SERVICE BULLETIN

Notification Number: **SB-08-04-26-1**

Subject : Continental Motors Rocker Shaft Inspection and Replacement. Reference attached Teledyne Continental Aircraft Engine Service Bulletin # SB08-1.

SUBJECT: ROCKER SHAFT INSPECTION AND REPLACEMENT

FIGURE 1
P/N 654375 ROCKER SHAFT INSTALLATION
(ROCKER ARMS REMOVED FOR CLARITY)

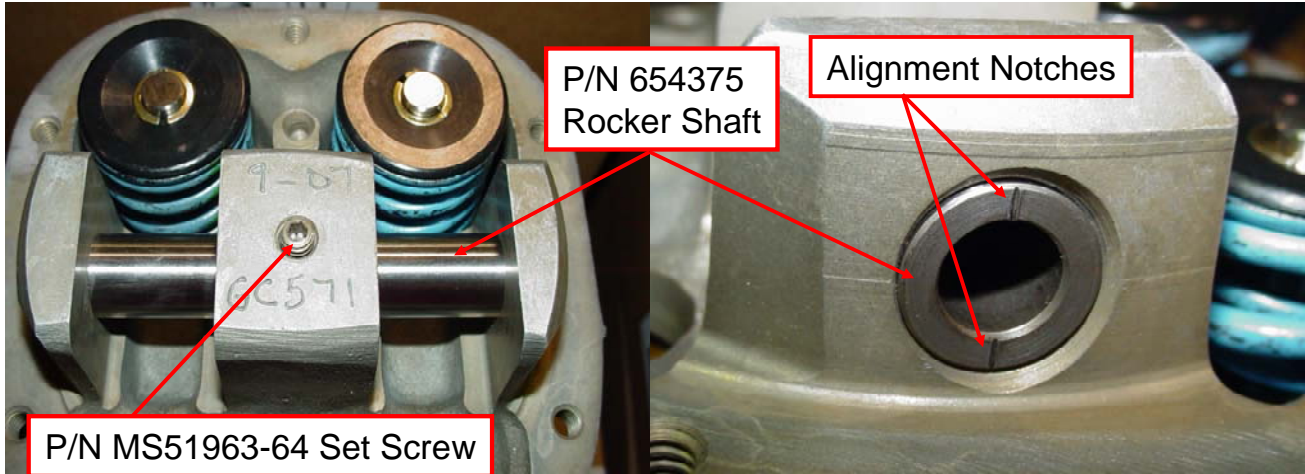
- 1) Using the airframe manufacturers maintenance instructions remove the engine cowlings and engine cooling baffles as necessary to access the cylinder rocker covers.
- 2) Remove the rocker cover from each cylinder.
- 3) Inspect each cylinder for the presence of the P/N 654375 Rocker Shaft and the P/N MS51963-64 Rocker Shaft Retaining Screw. (Reference Figure 1 and Figure 2) If the P/N 654375 Rocker Shaft is not installed, no further action is required. Go to step 6.

- 4) If the P/N 654375 Rocker Shaft is installed proceed as follows:
 - a) Rotate the engine to bring the piston to top dead center. Both valves will be closed.
 - b) Remove and discard the P/N MS51963-64 Rocker Shaft Retaining screw.
 - c) Remove the P/N 654375 Rocker Shaft and retain for return to TCM.
 - d) Reinstall the rocker arms utilizing a new P/N 21153 Rocker Shaft.

FIGURE 2
P/N 21153 ROCKER SHAFT INSTALLATION
(ROCKER ARMS REMOVED FOR ILLUSTRATION)

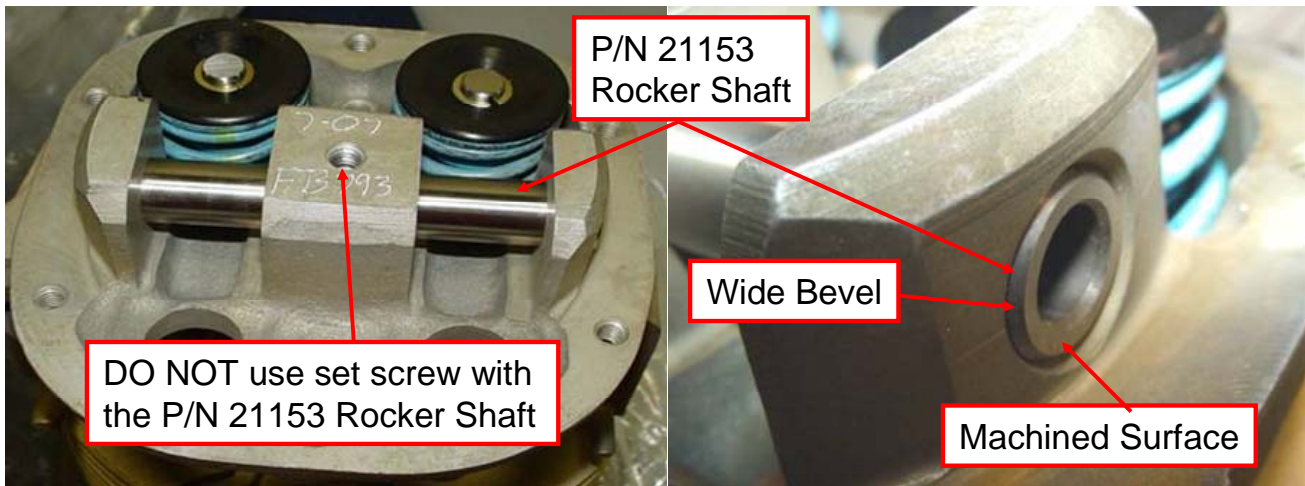
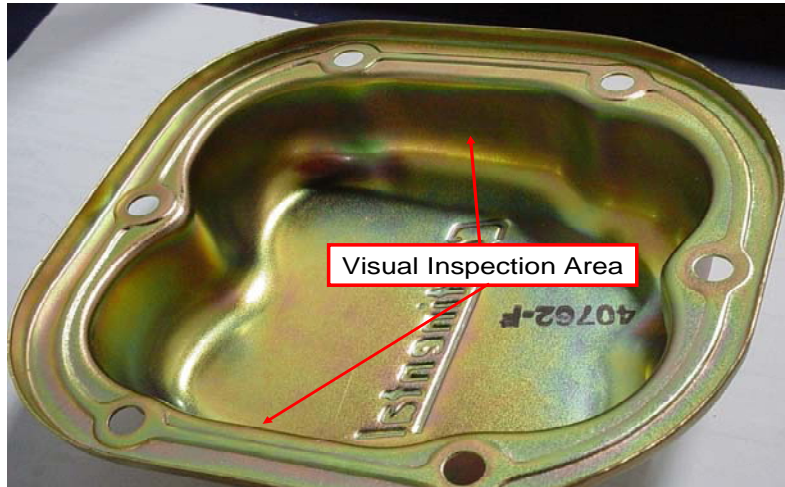
The P/N MS51963-64 Rocker Shaft Set Screw MUST NOT be used with the P/N 21153 Rocker Shaft.

**FIGURE 3
ROCKER COVER INSPECTION**

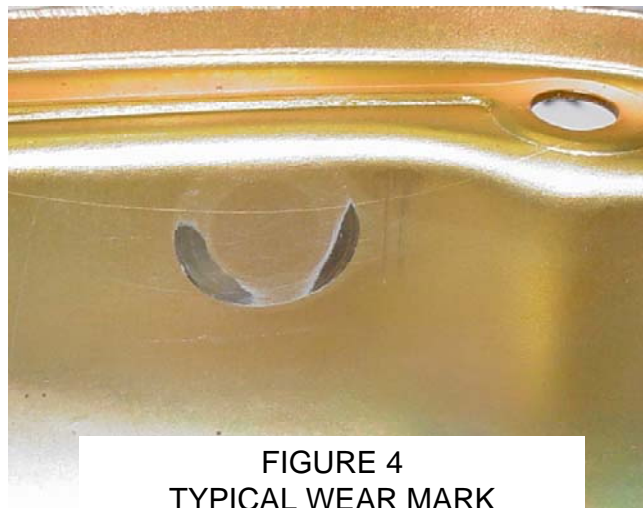
- 5) If the P/N 654375 Rocker Shaft was installed, inspect each Rocker Cover for chafing in the areas as indicated in Figure 3. If damage in the form of metal removal is found, the Rocker Cover must be replaced with a new P/N 40762 Rocker Cover. Acceptable wear pattern is shown in Figure 4.
